Cambridge City Council

## **DEVELOPMENT PLAN SCRUTINY SUB-COMMITTEE**

## **4 Ridgeon's, Cromwell Road Planning and Development Brief SPD (Pages 5 - 212)**

## **5 Draft Mitcham's Corner Development Framework SPD (Pages 213 - 290)**

**Figure 108: Site and surrounds.** Design principles to be addressed directly in the SPD:

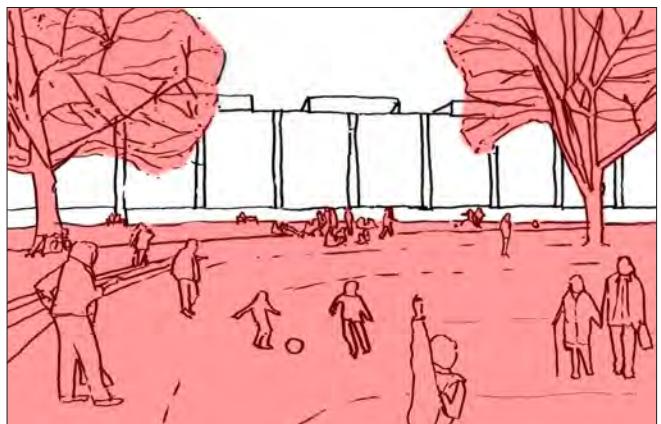
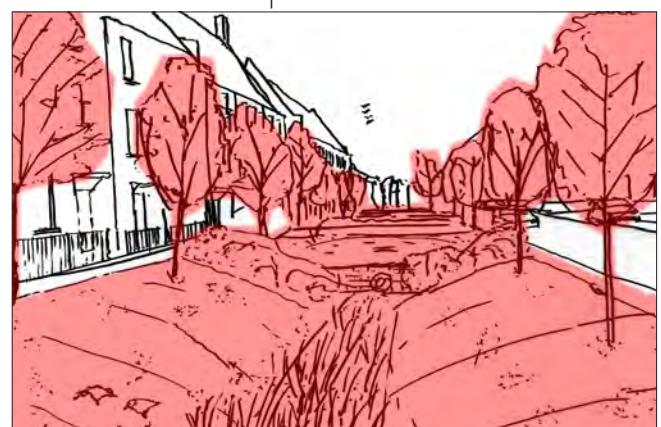
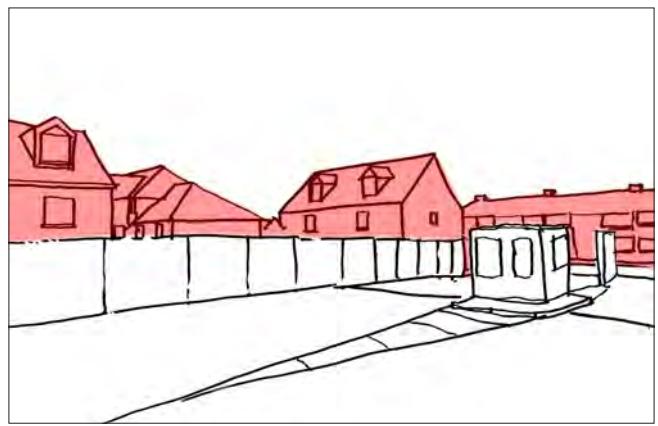
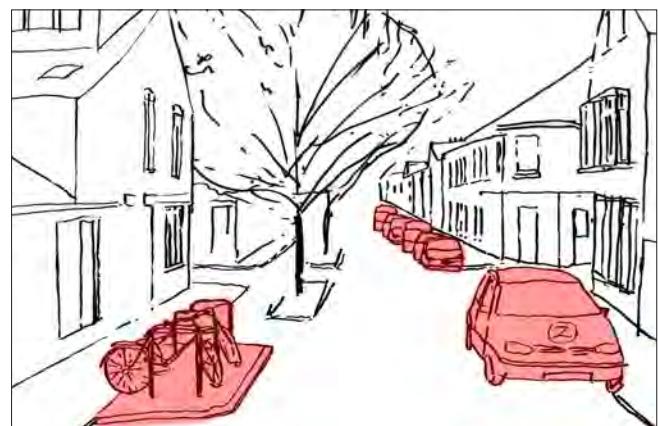
Figure 108 subfigure 6: Instead of "a variety of building heights" I would prefer to see "buildings of similar height to those already existing in Cromwell Rd and nearby streets between Mill Road and Coldham's Lane". The development near the station (CB1) has shown what dreadful results come from allowing developers to squeeze in more properties by building upwards. Over time such estates will become dilapidated squalid ghettos.

-Figure 108 shows a number of design principles for the site of which 4, 5, and 9 are transport-related. The County Council supports these but considers that the development should not only incorporate the Chisholm Trail (no 5) but should either deliver these directly or provide a contribution to cover the cost of delivery by the County Council.

Figure 108 subfigure 9: Indeed, ENOUGH car parking needs to be provided. Car parking is becoming an increasingly acrimonious issue in Cambridge, in part due to excessive prices for parking in central car parks, and in part due to charging at park and ride sites. Where people live, they are bound to want to park, and modern couples often find themselves both with jobs and both needing to drive to work as the only option. Providing only one car parking space per property is just inviting car parking wars.

**Figure 109:** For the **wider area**, the following design principles have been considered when preparing the SPD:

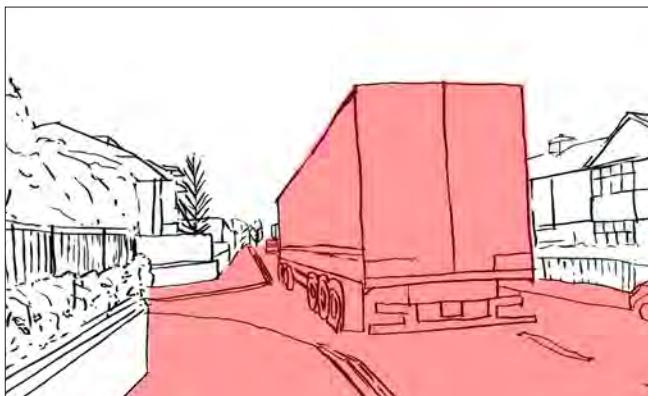
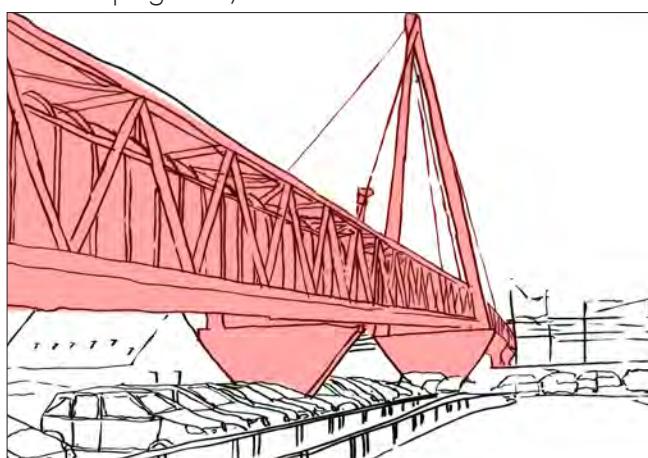
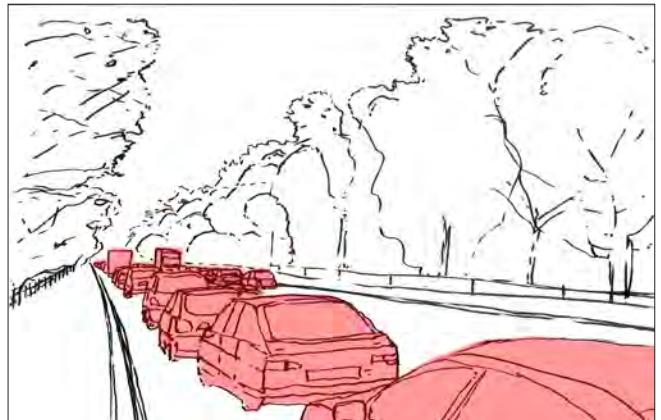
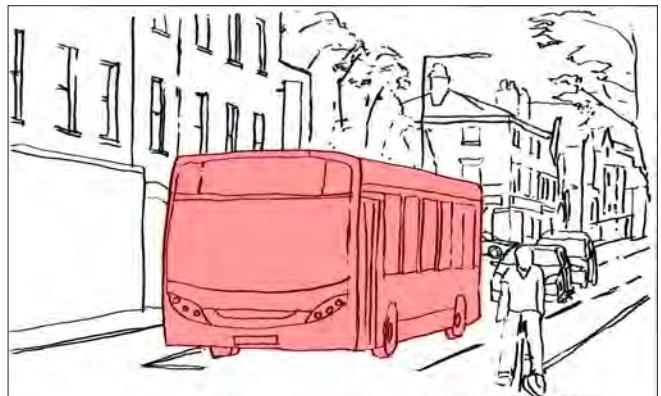
-Figure 109 shows principles for the wider area. Both points 13 and 14 should be addressed via a full Transport Assessment that should accompany any future planning application.

**Figure 111**  
**Framework Plan**

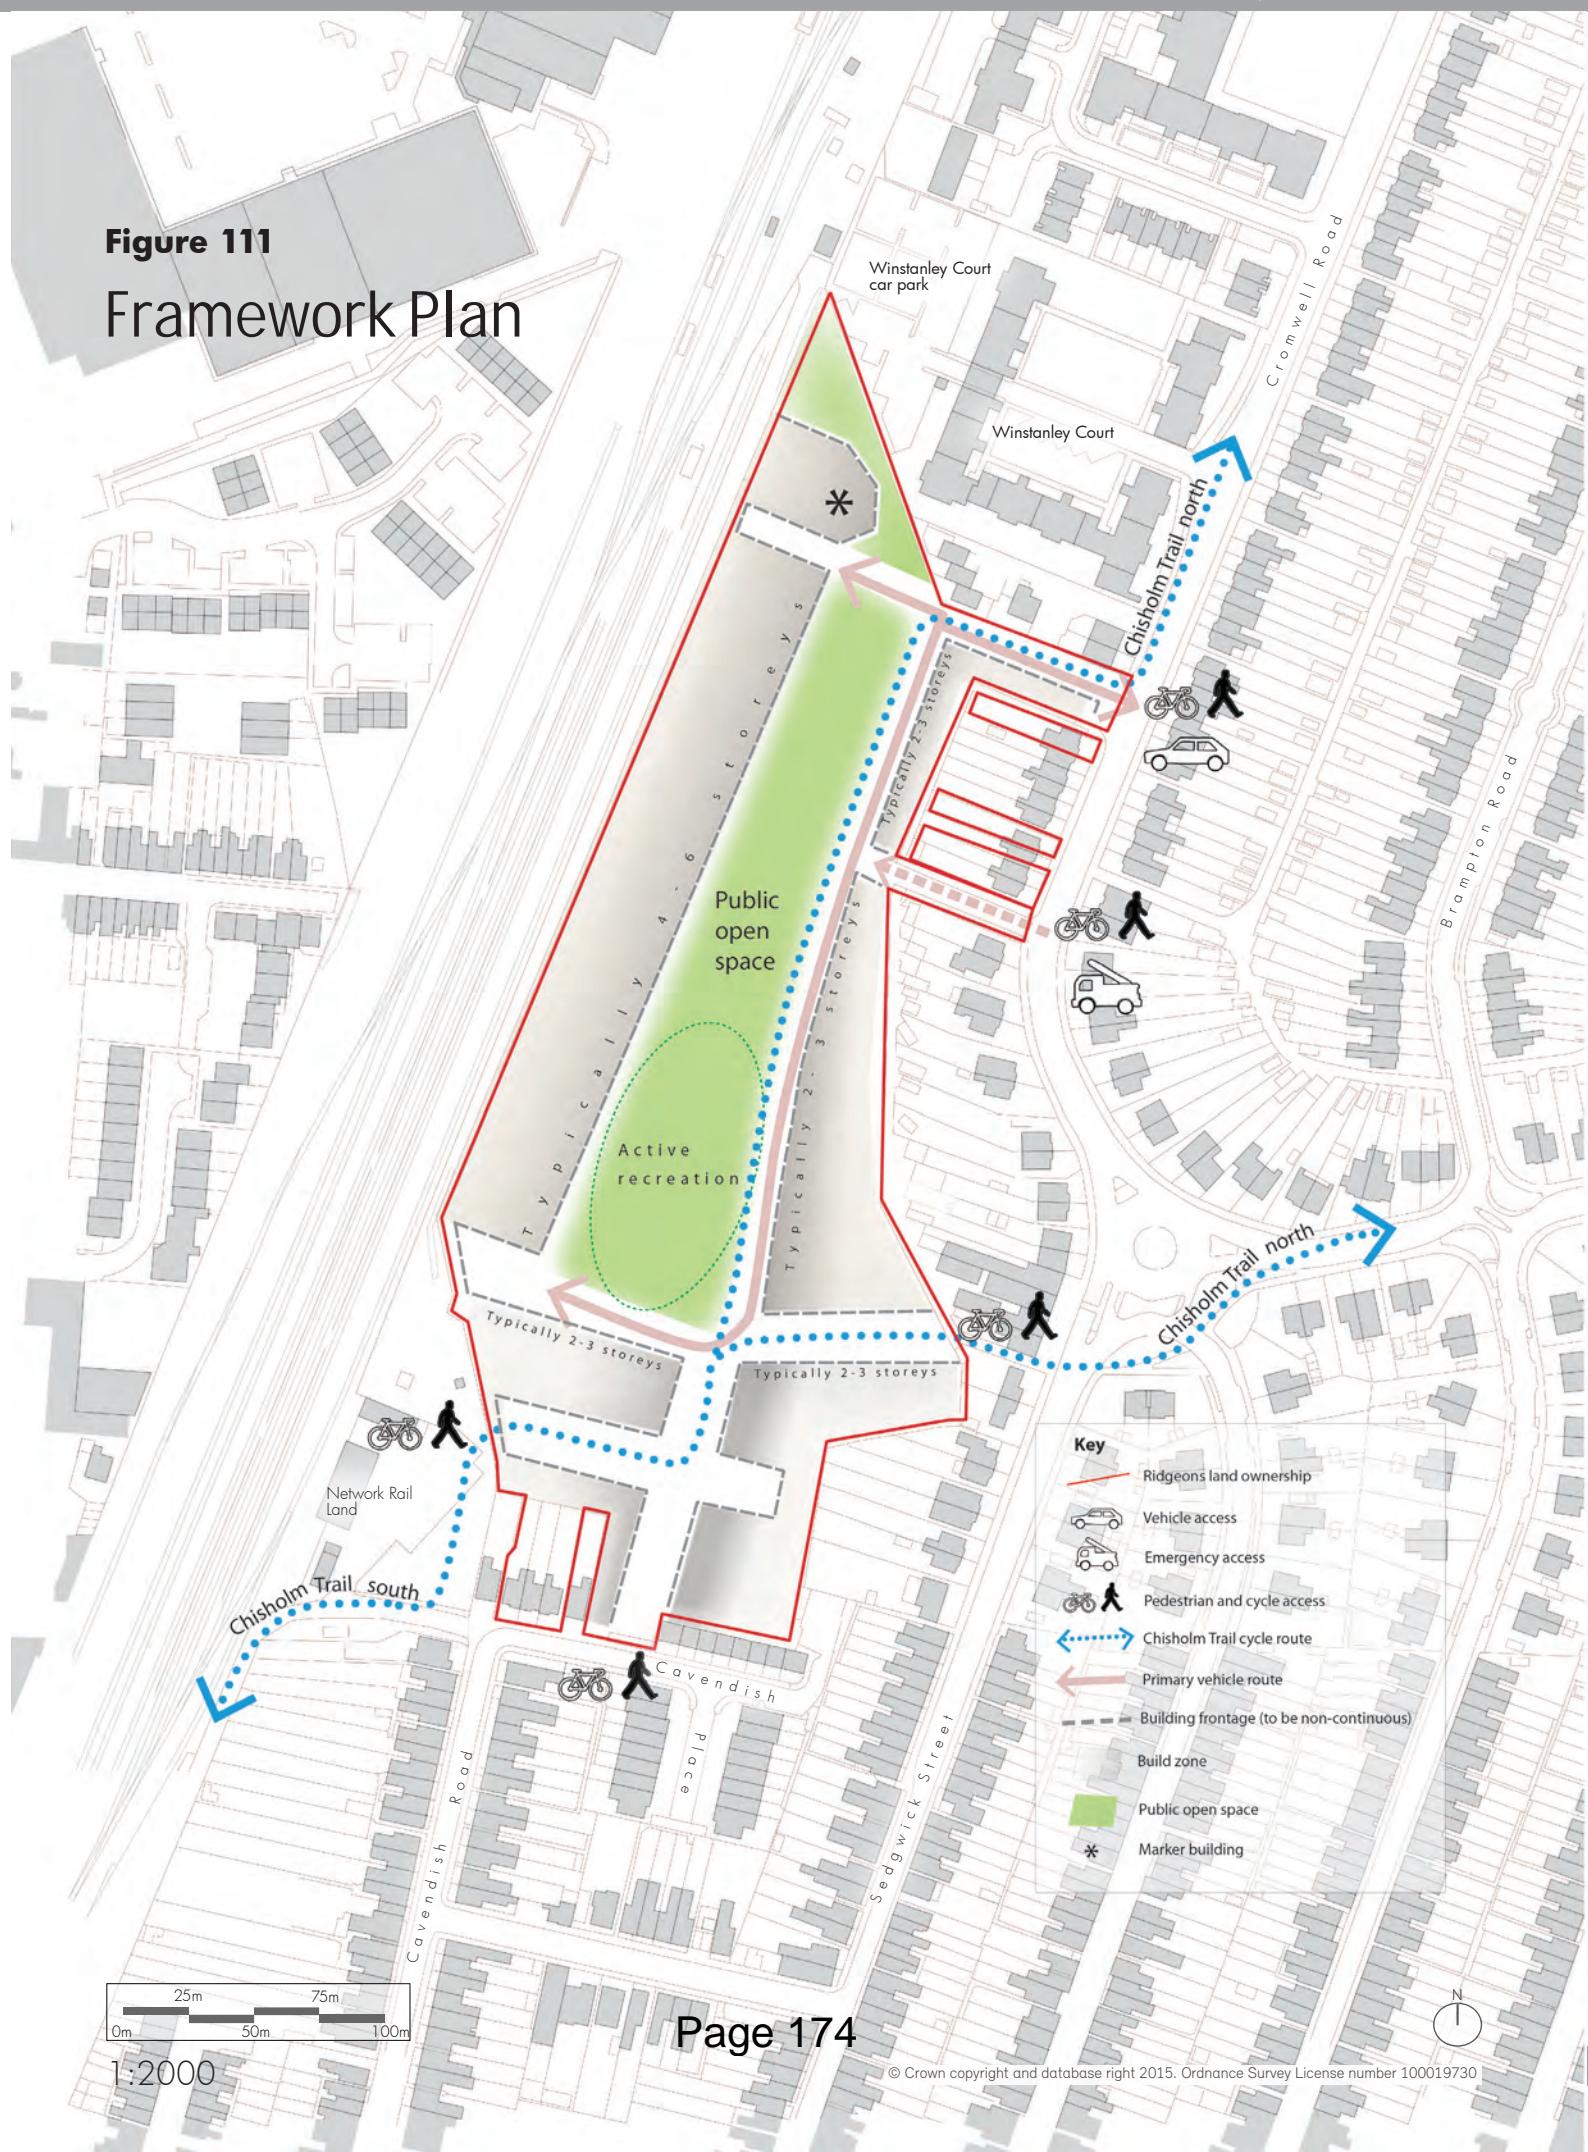
The suggestion on pages 36 Figure 72, on page 52, Figure 107, and again on page 65, Figure 111 all suggest a primary network would allow cycles to enter Cavendish Road with an expectation I suspect that they access Mill Road. This is a move away from the plan on page 33 and raises concerns if allowed to happen without a rethink of the arrangements on Cavendish Road.

Comments noted. Figure 111 shows both Cavendish Road and Cavendish Place. The point at which the road name changes is not marked. It is not considered necessary or desirable to show this level of detail as part of the context information as to do so would over complicate the drawing as many other such points of clarification would be needed to be added to the plan also. It is also not possible to show all extensions that have been added to nearby properties. The context plans rely on OS based data which will not be up to date. It is not possible to accurately update each and every change to nearby properties that may have occurred since the OS data was issued. The context information should not be treated as an accurate reflection of building forms that exist off site. A detailed assessment of the site's context would be undertaken visually during the consideration of any planning application.

Figure 127: Street typology 3 - Indicative park frontage

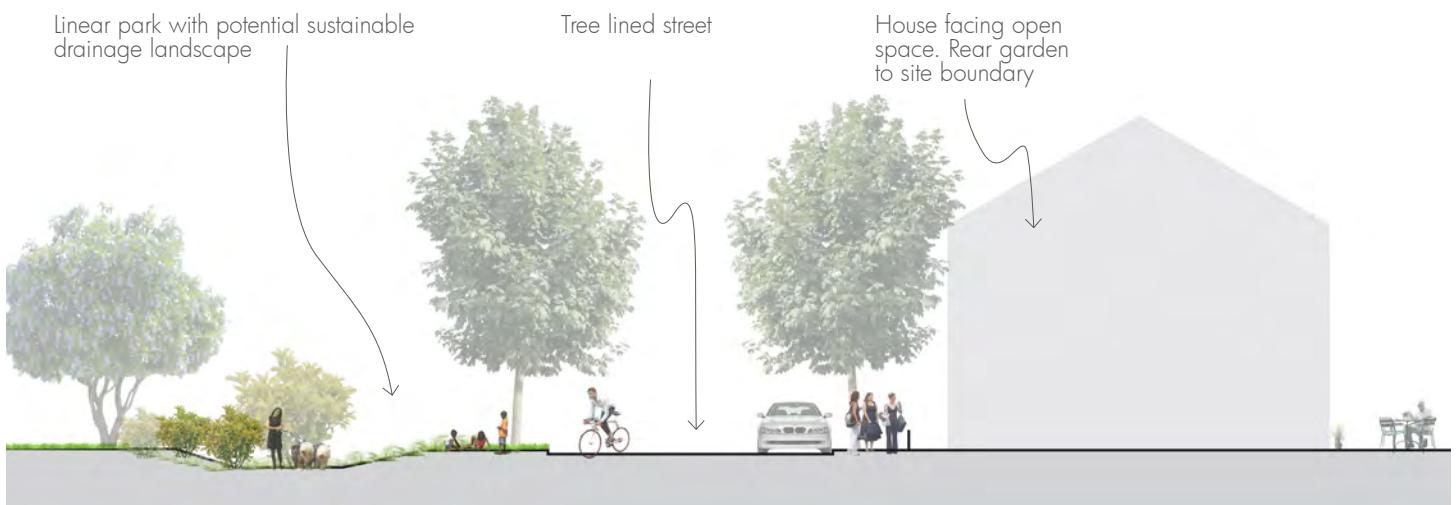
There are inconsistencies in the document to how roads are depicted - or whether they are depicted at all. Page 79 of the document and figure 127 depict a road that is running North South behind the main block of flats. This is not illustrated elsewhere in the document and it is difficult to understand how this works with the street network as currently shown on Figure 123 Access and Movement

**Comments noted.** Many of the illustrations provided within the SPD (such as Figure 123) are showing general locations where development might occur rather than the outline of specific buildings. Figure 123 also illustrates the primary vehicle network only. Secondary routes will also be provided, including, in all likelihood, a route running adjacent to the railway in some form. This is however a matter of detail that will be provided as part of any planning application lodged. In terms of the illustration of development occurring within the entrance into the site, this is an indicative section only. Built form has however been shown here as there may be merit in providing built form here to create a more domestic feel to the entrance (rather than the very wide commercial type entrance that exists at present). The precise layout of buildings will again be determined at the planning application stage.

**Figure 135****Building heights and types**

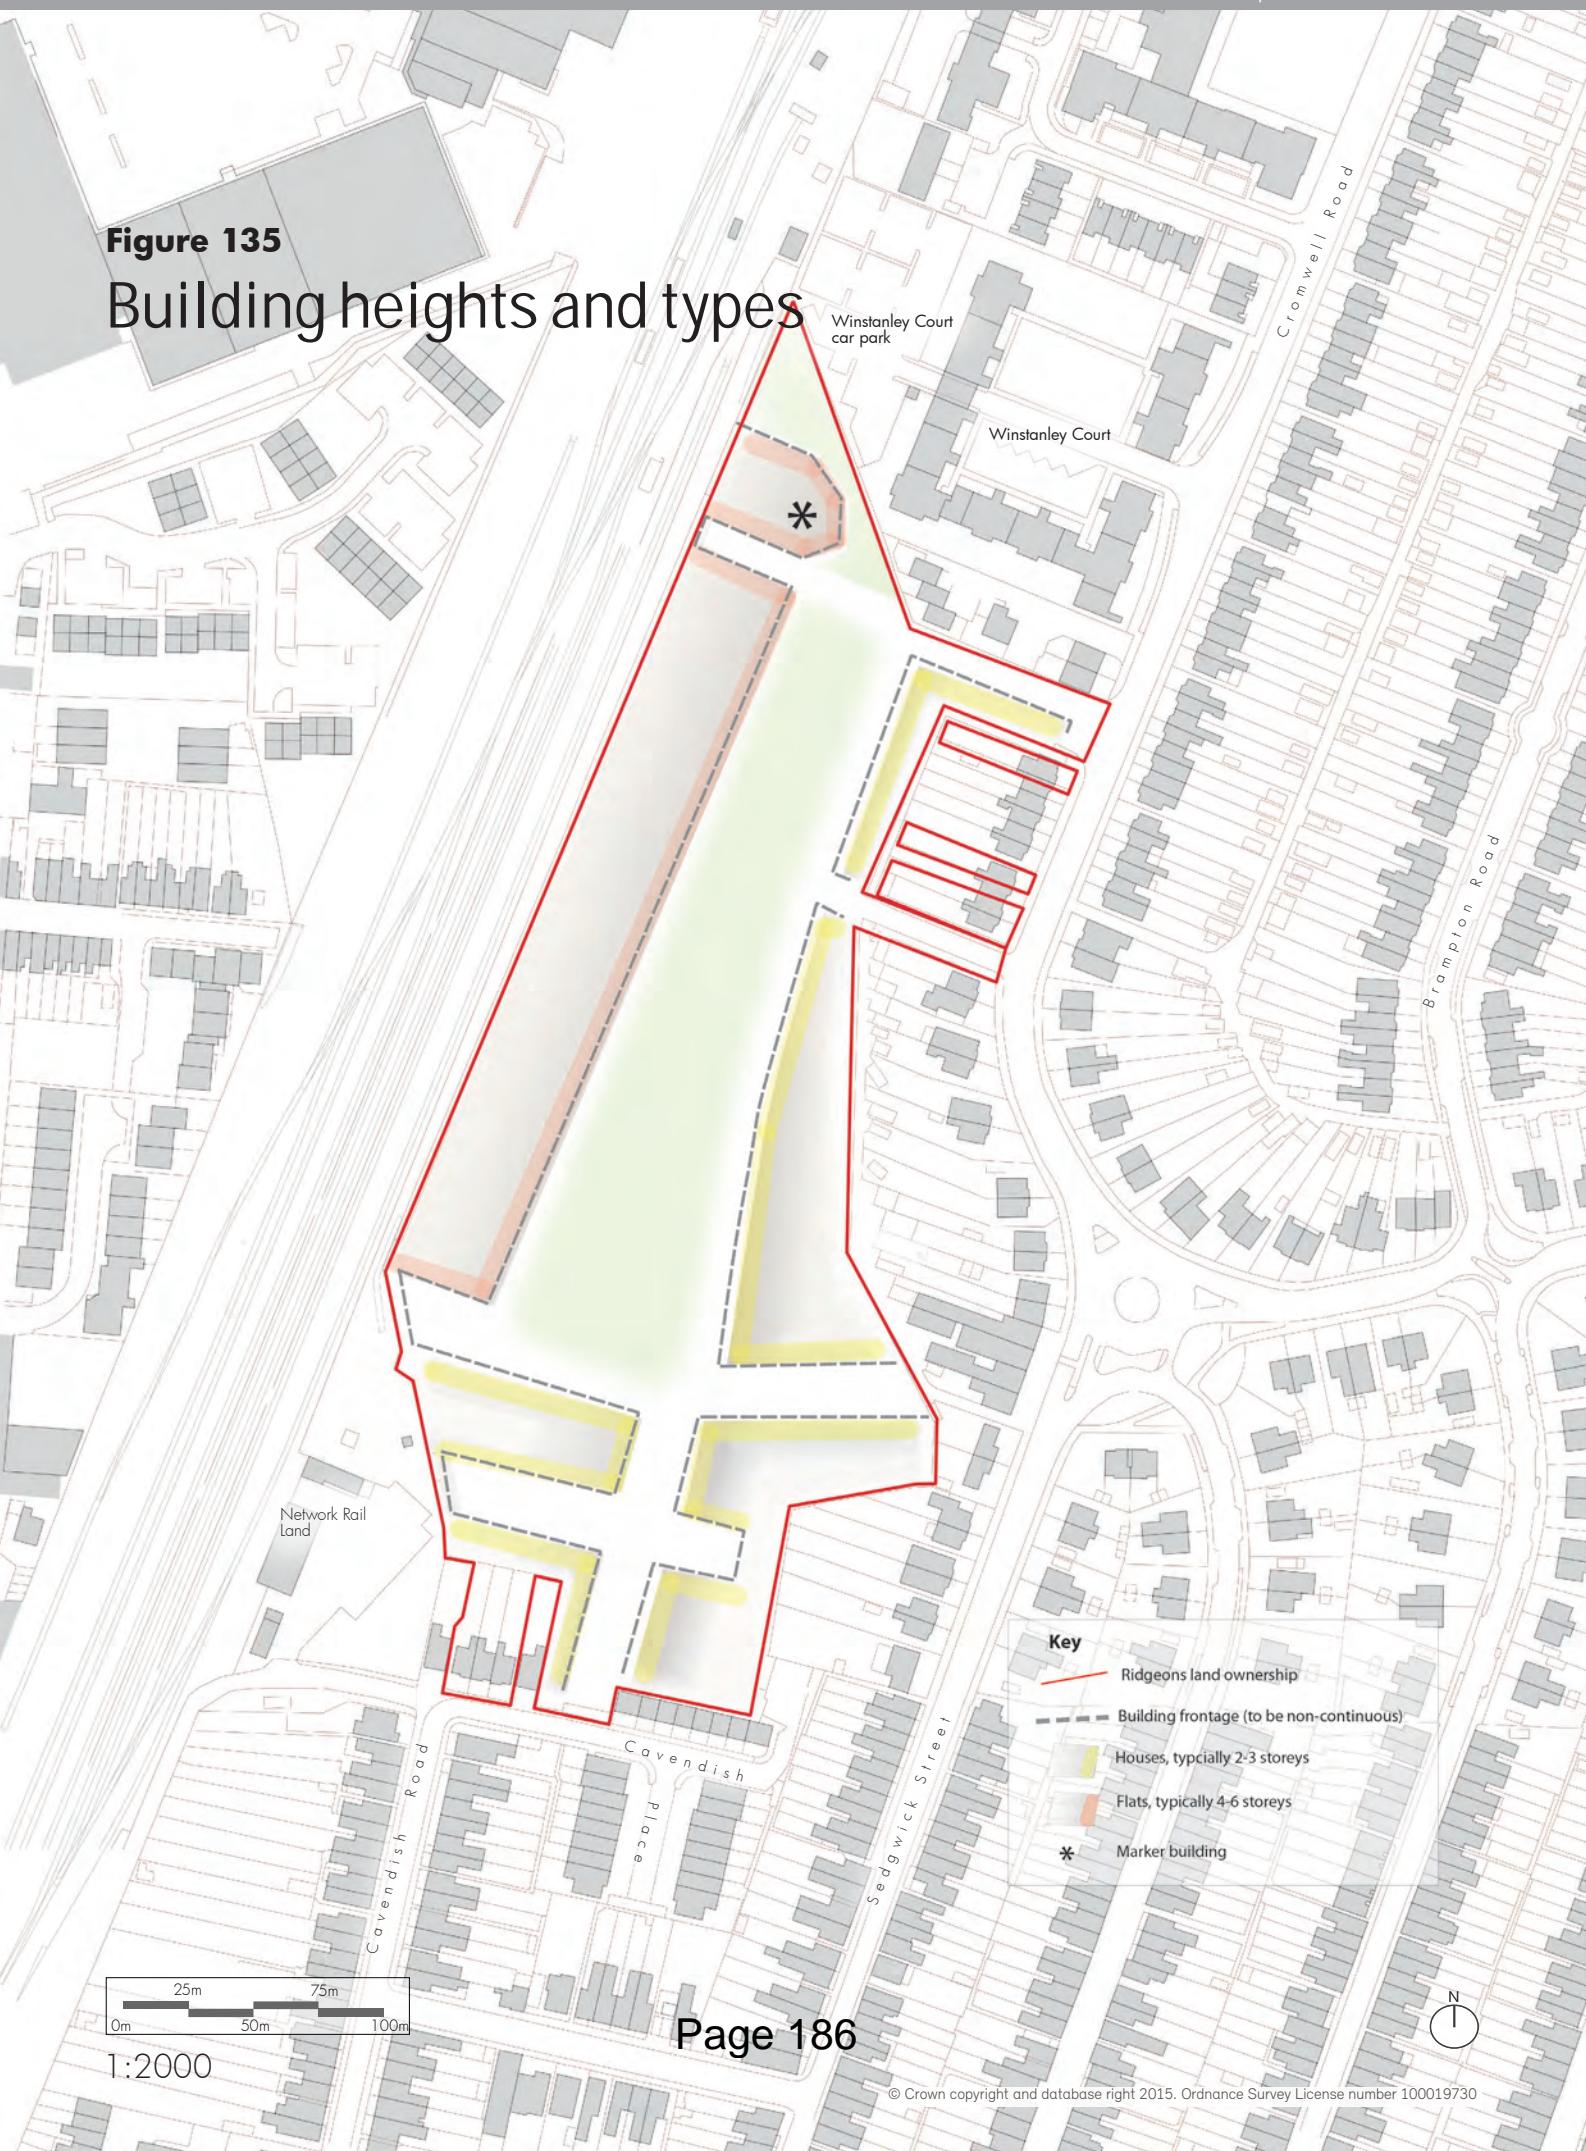
Figure 115 indicates the opening onto Cavendish Road/Place and this is a little clearer on page 77 Figure 135. However, I am also concerned that since the ownership of 133 Cavendish Road has been recognised as not being part of the site, the 'Indicative character and form' shown on page 79 Figure 136 is unclear. More detail is needed about how the junction with Cavendish Road/Place is proposed. Real consideration is needed with this junction to both safety and the aesthetics of how it will affect my property at 96 Cavendish Road and surrounding properties.

Comments noted. Figure 135 shows both Cavendish Road and Cavendish Place. The point at which the road name changes is not marked. It is not considered necessary or desirable to show this level of detail as part of the context information as to do so would over complicate the drawing as many other such points of clarification would be needed to be added to the plan also. It is also not possible to show all extension that have been added to nearby properties. The context plans rely on OS based data which will not be up to date. It is not possible to accurately update each and every change to nearby properties that may have occurred since the OS data was issued. The context information should not be treated as an accurate reflection of building forms that exist off site. A detailed assessment of the site's context would be undertake visually during the consideration of any planning application.

Comments noted. The broad height of buildings is set out within Figure 135. The final scale and design of individual buildings and blocks will be set out within any planning application that is made. The response to the site's context and character will need to be justified within the Design and Access Statement.
